# SERVICE BULLETIN

Classification: EL15-016a	Reference: NTB15-066a	Date: December 16, 2015
------------------------------	--------------------------	----------------------------

## 2015 MURANO; AV CONTROL UNIT AND A/C SWITCH ASSEMBLY SERVICE INFORMATION

This bulletin has been amended. SERVICE INFORMATION has been moved to page 2.  
CLAIMS INFORMATION has been corrected. Discard previous versions of this bulletin.

Figure 1: Location of A/C switch assembly P/N

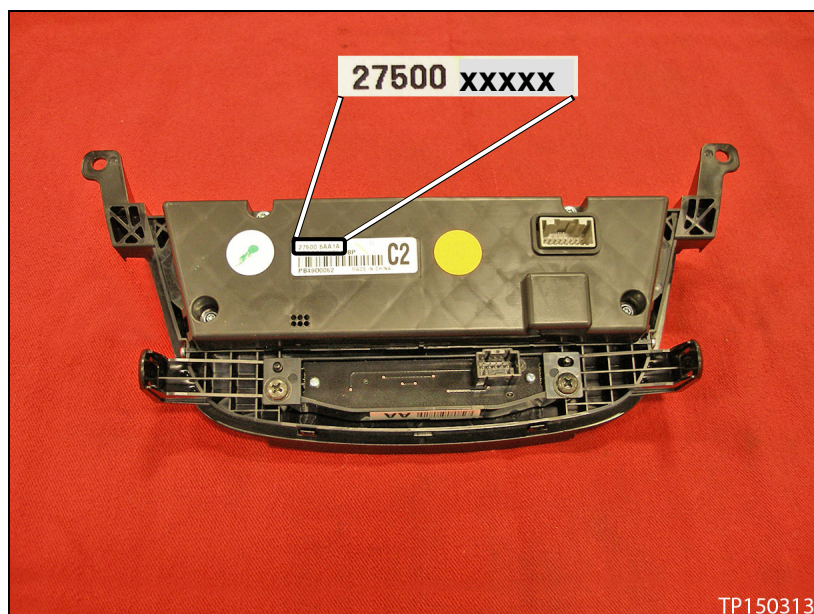
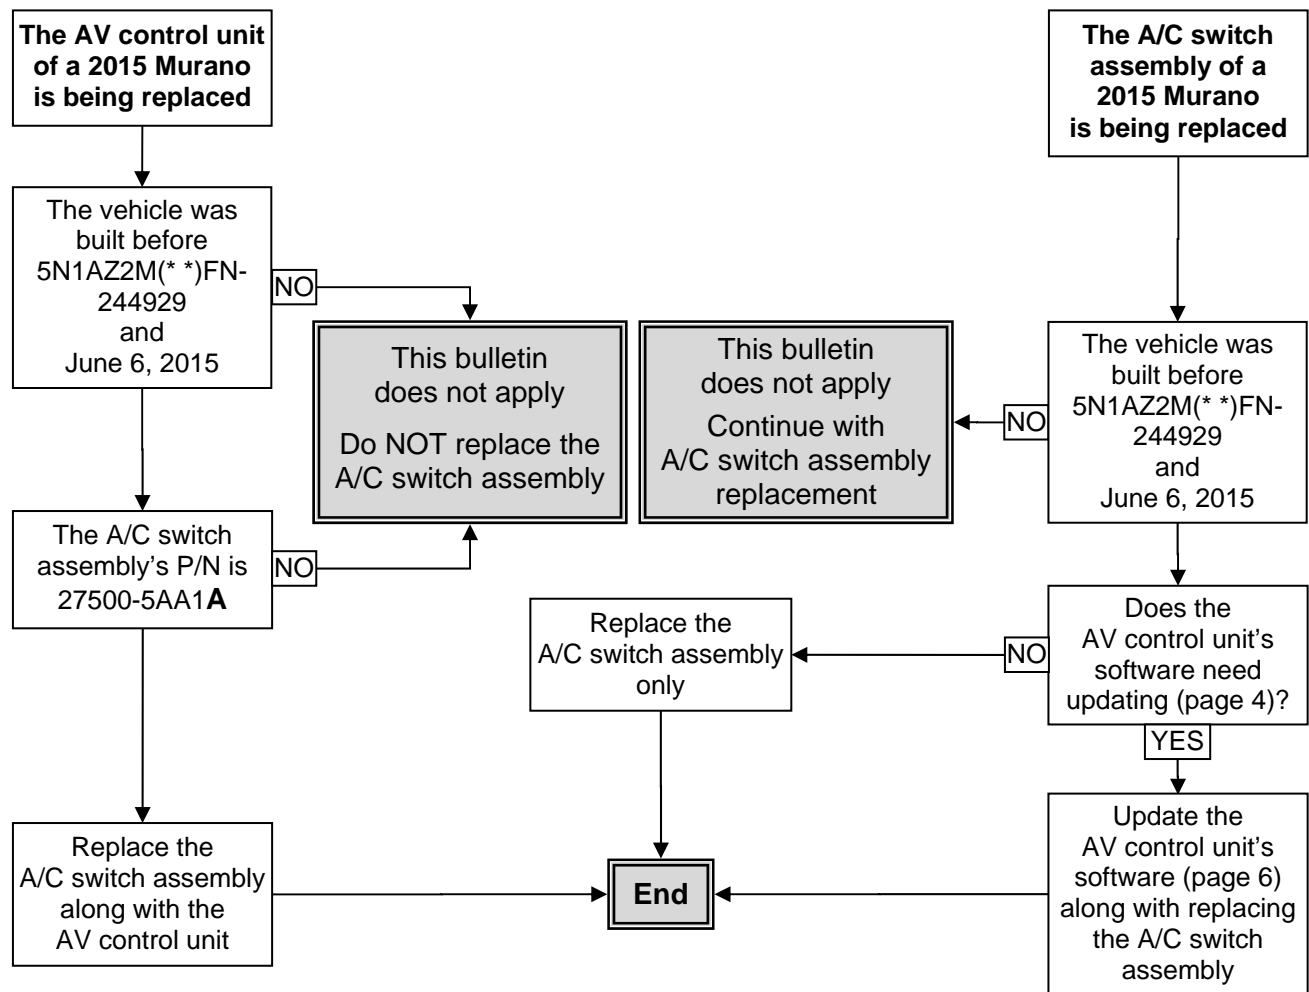
Whenever an AV control unit on an applied vehicle is replaced for any reason, check the part number (P/N) of the A/C switch assembly (A/C Controller Assembly).

- If the P/N is 27500-5AA1**A**, replace the A/C switch assembly with 27500-5AA1**B**.
- If the P/N is NOT 27500-5AA1**A**, do NOT replace the A/C switch assembly.

**NOTE:** The A/C switch assembly P/N can be checked by the following:

- While removing the AV control unit (see page 3, Figure 1)
- Access Service COMM for previous warranty repairs that included A/C switch assembly replacement (it would list the replacement P/N)

Figure 5

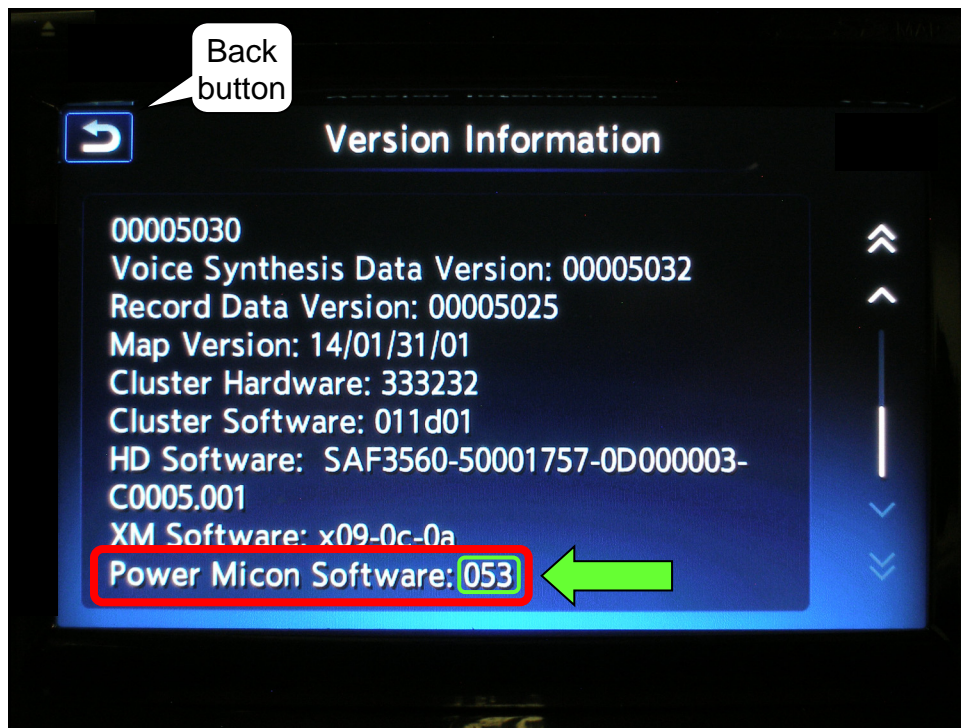
6. Check the software number next to **Power Micon Software**.

- If **054** or higher, a software update is not needed, or has been successfully performed.
- If less than **054**, a software update needs to be performed.
- If a software update needs to be performed, leave the screen as is, and then go to page 6, **AV Control Unit Software Update with Software Update SD Card**.
